złączka węża Makita 459223-1 (413490-2)

DC179

Title	Change of Arm set, Joint, Hose connector, Dust nozzle Elimination of O ring 20, O ring 23 Addition of Rivet 7
Model	DSL800, XLS01
Country	All countries
Description	To improve the dust collecting efficiency; • Arm set, Joint, Hose connector and Dust nozzle will be changed. • O ring 20 and O ring 23 will be eliminated. • Rivet 7 will be added.

[1] Arm set (183L76-5)

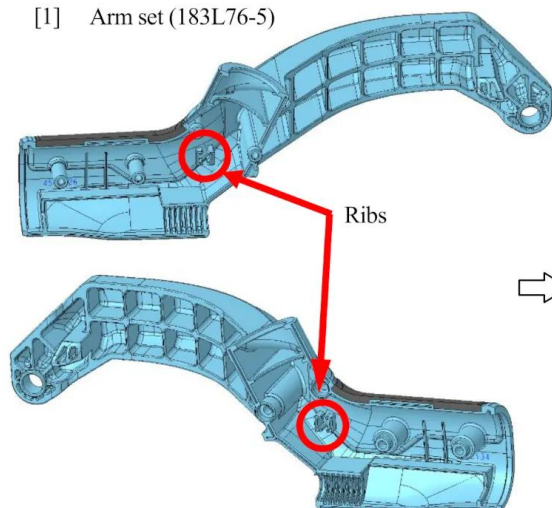
Arm set (183T15-3)

[2] Joint (459222-3)

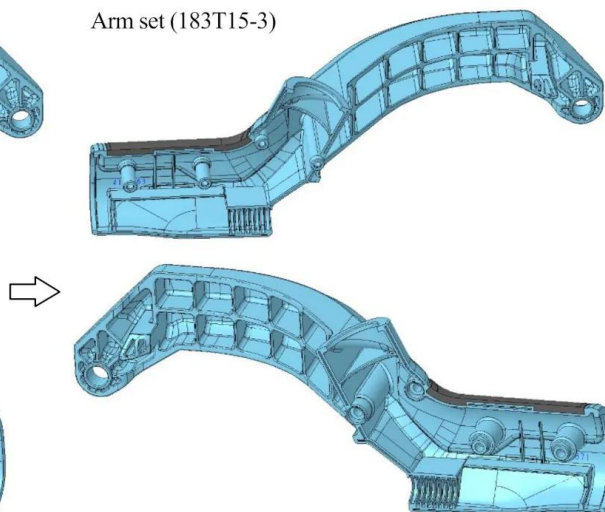
Joint (422617-3)

- [4] Elimination of O ring 20 attached to the current Joint
- [5] Elimination of O ring 23 attached to the current Joint

[6] Dust nozzle (459234-6)

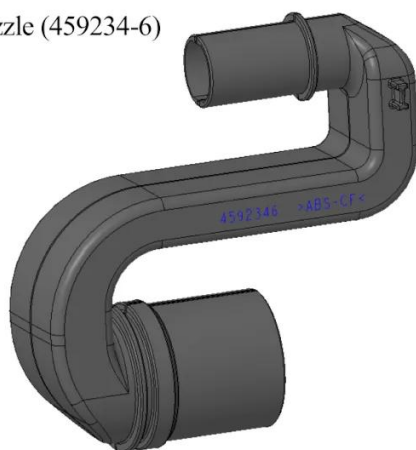
Dust nozzle assy (127672-7)

[7] Addition of Rivet 7 (412987-8)

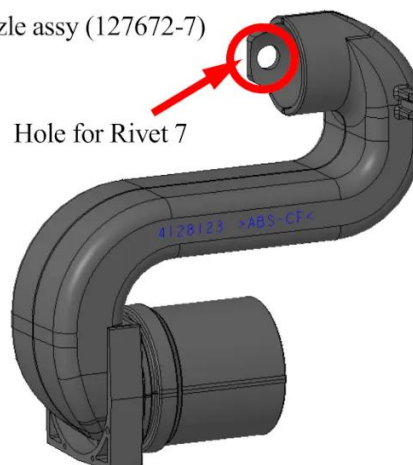
Insert Pipe B complete into Dust nozzle assy, then fasten them with Rivet 7 (412987-8).
